**BEFORE THE HEARINGS PANEL
FOR THE QUEENSTOWN LAKES PROPOSED DISTRICT PLAN**

IN THE MATTER of Hearing Stream 13 –
Queenstown Mapping
Annotations and
Rezoning Requests

**REBUTTAL EVIDENCE OF MARION READ
ON BEHALF OF QUEENSTOWN LAKES DISTRICT COUNCIL**

LANDSCAPE

APPENDIX 3: Proposed landscape category boundary lines around Quail Rise (shown as a thick black line).

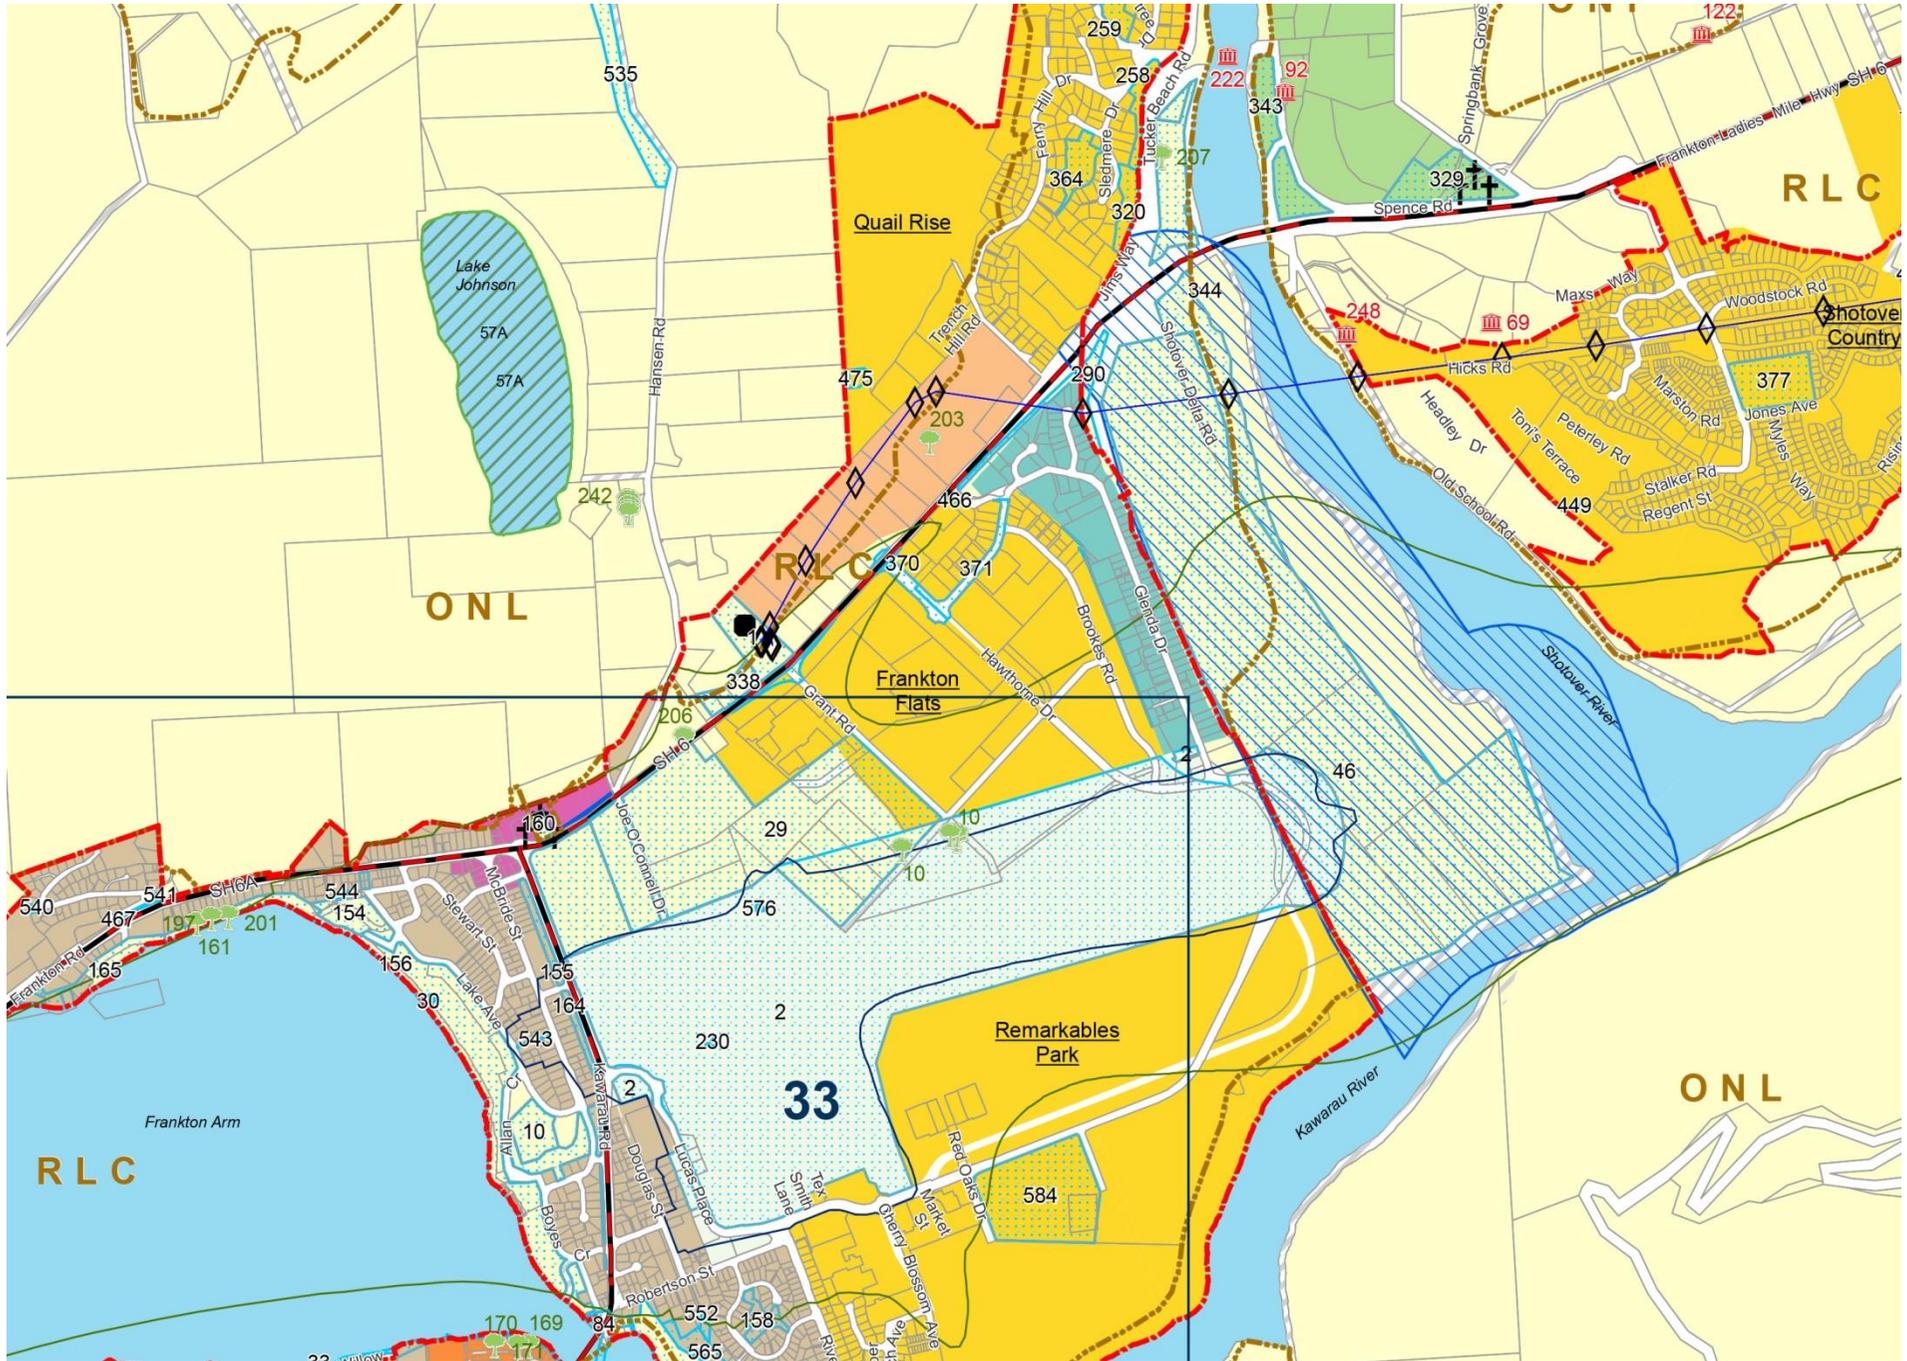
- 5.14** As noted in my evidence in chief, the point at which I consider that the boundary appropriately climbed the hill occurs on the property at 145 Frankton – Ladies Mile. The reasoning behind this is that the more northern part of this property, at the time I did my original assessment, had had earthworks undertaken which affected the natural interface of the land forms. The neighbouring property to the north west has a dwelling located right at the topographical transition and had an extensive garden extending up the slope. Consequently I drew the boundary to exclude these features and to skirt up the hill to meet up with the south western corner of the Quail Rise zone.

- 5.15** This is a relatively arbitrary location with little specific landscape justification. It does exclude the northern corner of the Flats and hummocky moraine material which is located in the north eastern part of Lot 2 DP 497316 which is a part of the landforms over which the south western portion of the Quail Rise development is located. That is, this hummocky landform is neither a part of the Flats nor a part of Ferry Hill.

- 5.16** I note that Mr Espie's review of the landscape boundary (undertaken at the time of the release of the boundaries report) produced a boundary almost identical to mine, and that in fact it is Mr Espie's line which has been included in the notified PDP.

- 5.17** Mr Ferguson has included in his evidence a copy of an email sent from me to Mr D Curley on 13 February 2015 in which I state that the line which was sent out for consultation is in the wrong place and that all of Lot 2 DP 497316 is outside of the ONL. I have checked all my records and, other than the email itself, I have no other documentation which sheds light on the context or detail of this email. However, I have looked at the maps I prepared in 2011 and 2014. These maps show that the ONL line recommended by me is in the same location as the notified ONL, and I was therefore in error in my response to Mr Curley. I attach the first map of the area drawn by me

PROPOSED ZONE CHANGE
 Lots 1 & 2 DP 307630 & Pt Sec 1 SO 24074
 ARTHURS POINT
 FOR GERTRUDE'S SADDLERY LTD

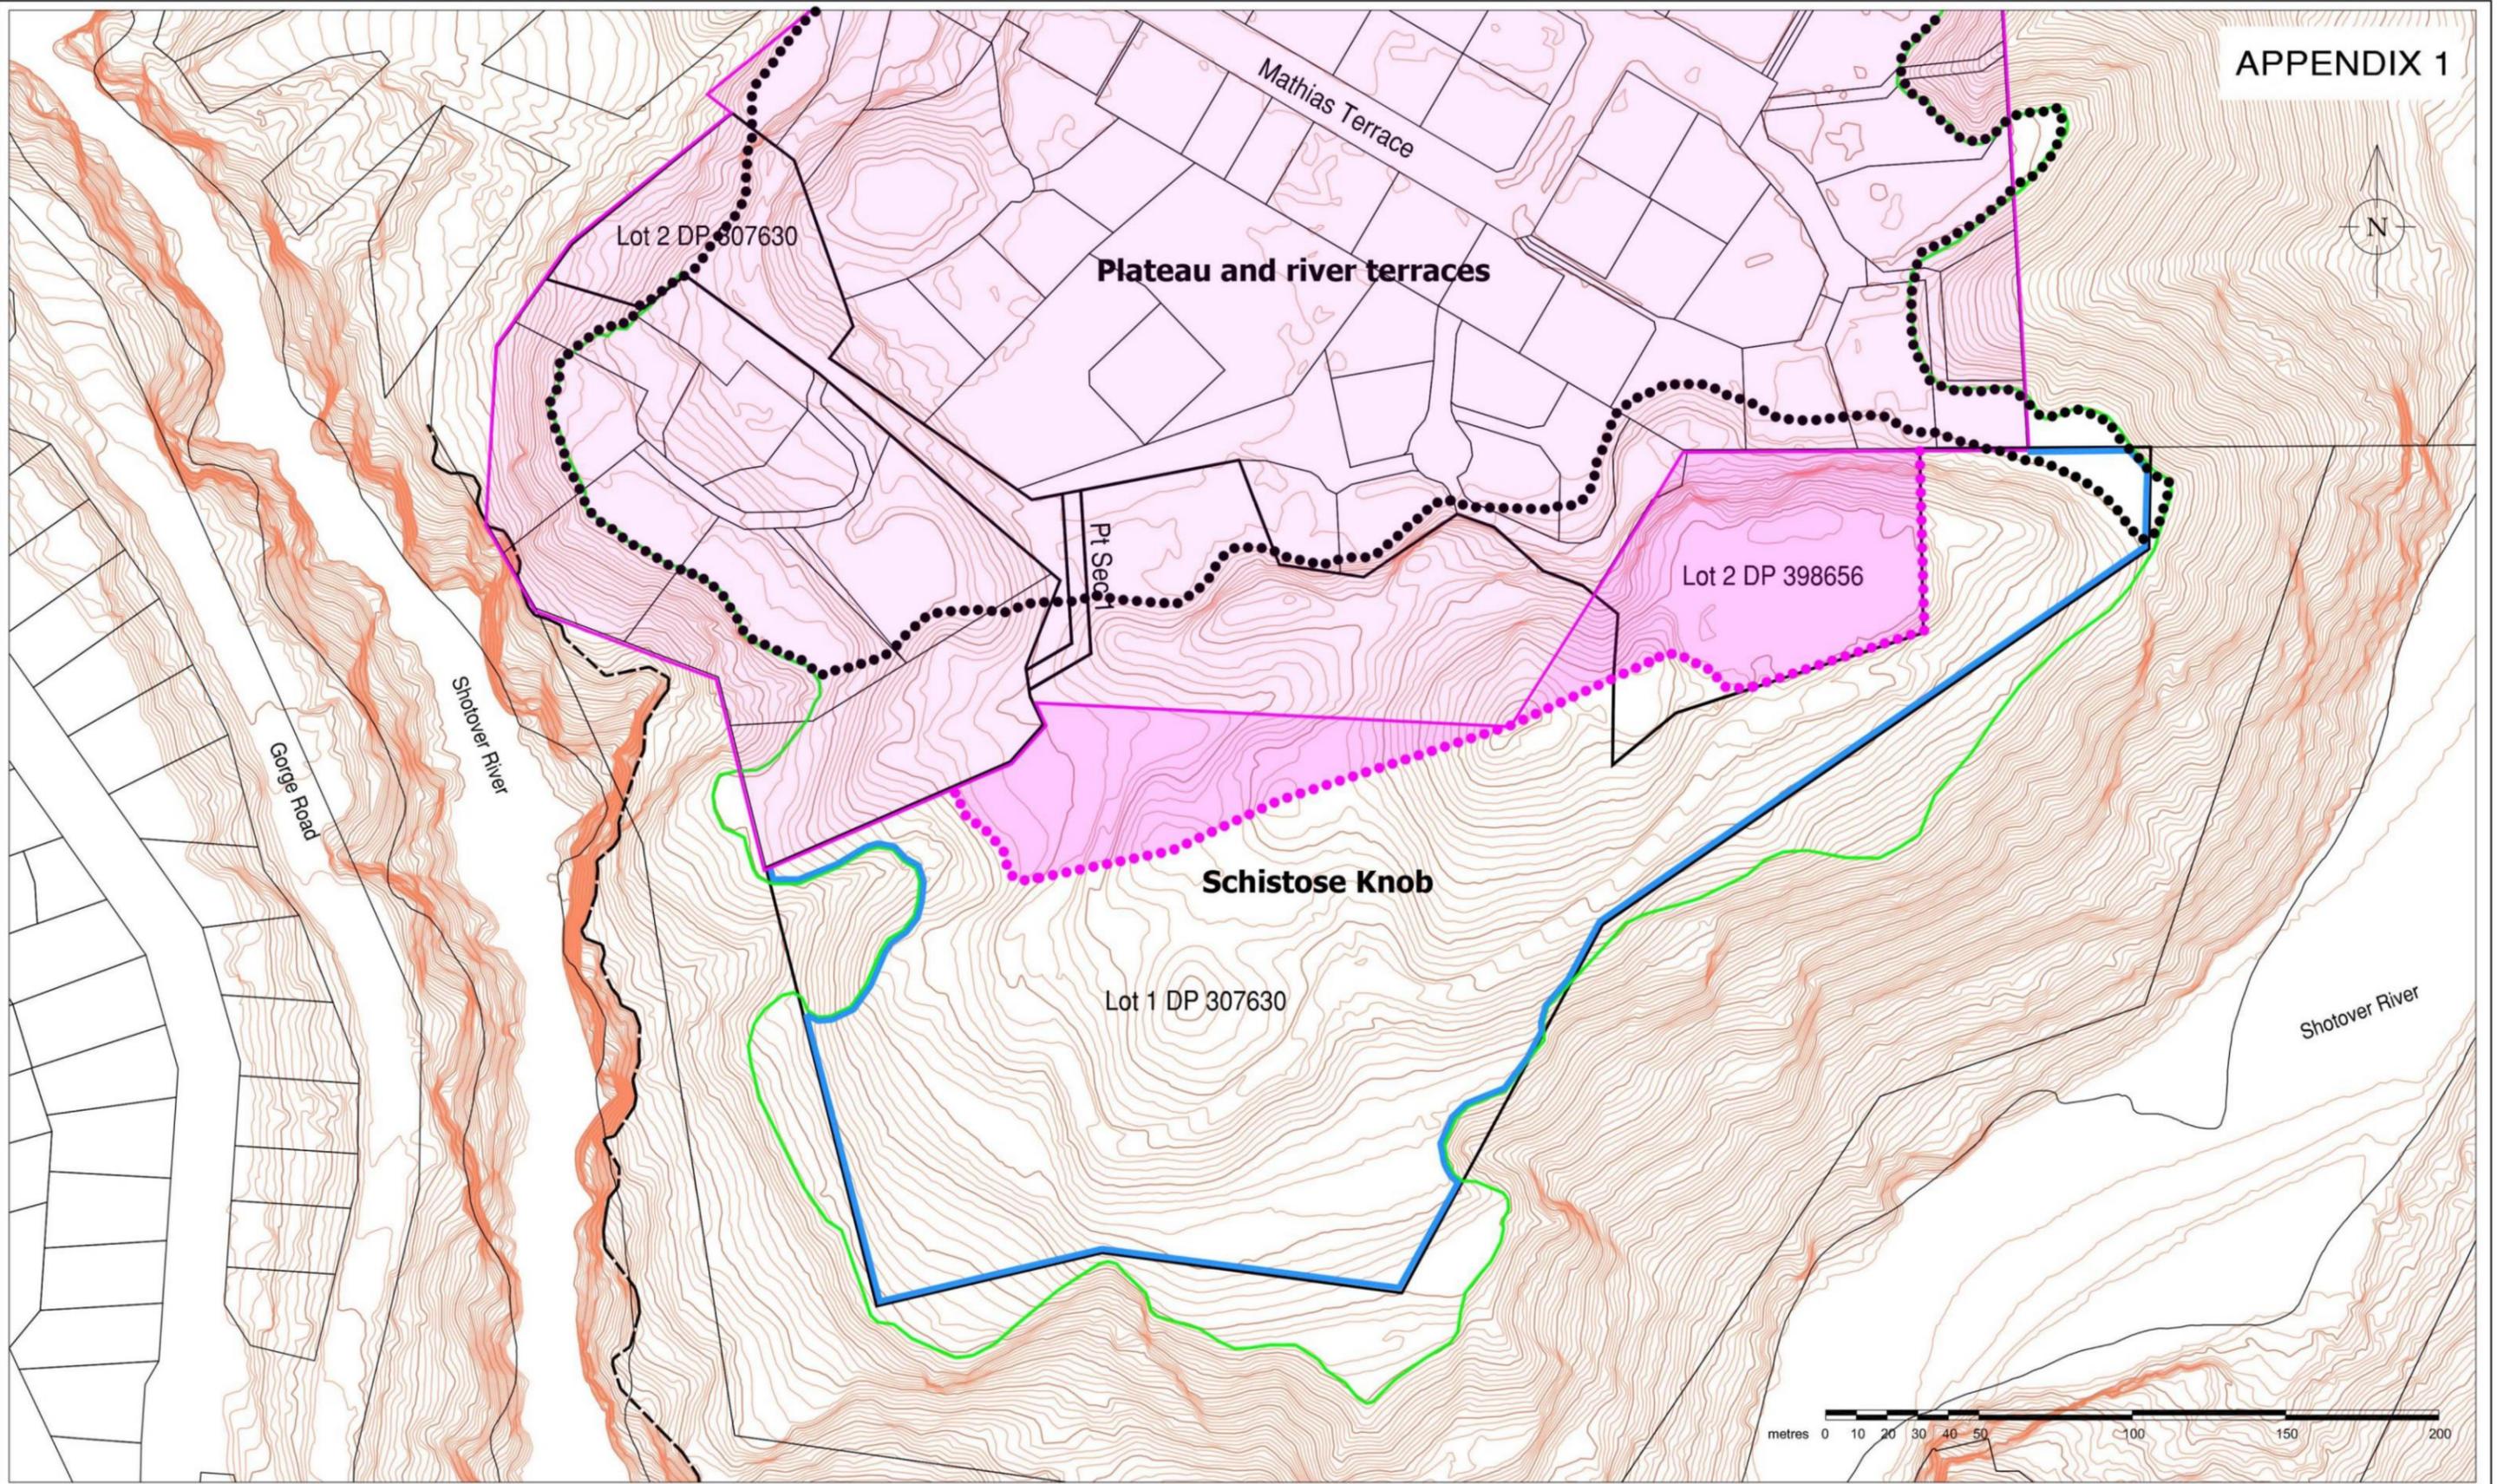
- 6.6** Mr Espie's map at his Appendix 1 is very helpful, providing a high level of topographic detail of both the subject site and a key part of the Shotover Gorge. Mr Espie has located on this plan a green line which he considers to be the boundary of the ONF of the gorge. I agree with this location as it relates to the subject site.

- 6.7** Mr Espie does not consider the subject site to be ONL. He notes that the zone boundaries in the Arthurs Point area, which are *de facto* landscape boundaries if it is accepted that the development area is surrounded by ONL, do not follow changes in landform or landscape character. I agree that this is the case but note that zone boundaries within the District rarely, if ever, coincide with landscape boundaries in this way.⁴ I have identified on his plan (my **Attachment 4**), where I consider the actual boundary of the terrace and plateau landform on which this eastern portion of Arthurs Point is located with a black dotted line. I think that in both Mr Espie's and my own ideal worlds this would have been the boundary of the Low Density Residential Zone. I note that this excludes the majority of the subject site, including most of the portion of it currently zoned LDR. That is, the zone boundary transgresses this landscape boundary. I have identified the notified LDR in pale pink. Mr Espie continues to state that the land within the subject site which is zoned LDR does not differ in character and quality from the adjacent land which is zoned Rural and that this is a reason to consider the Rural land to not be ONL.

6.15 I continue to consider that some more of the northern side of the knoll could be rezoned LDR without significant additional adverse effects, either visual or on the landscape character and quality. This is because the cumulative effect of the additional development with that which is already anticipated would not be significant. I have identified where I consider that the LDR boundary could be located with a pink dotted line on Attachment 4 and identified the area on which additional LDR zoning could be appropriate in dark pink. In this scenario views from Watties Track would remain unchanged from those anticipated. Views from the west would include more development but with a substantially natural backdrop, albeit diminished in scale. I consider that extending the LDR boundary to the location identified by Mr Espie would have significant and adverse visual effects from a wide catchment, and would allow urban development to impinge significantly on the ONL.
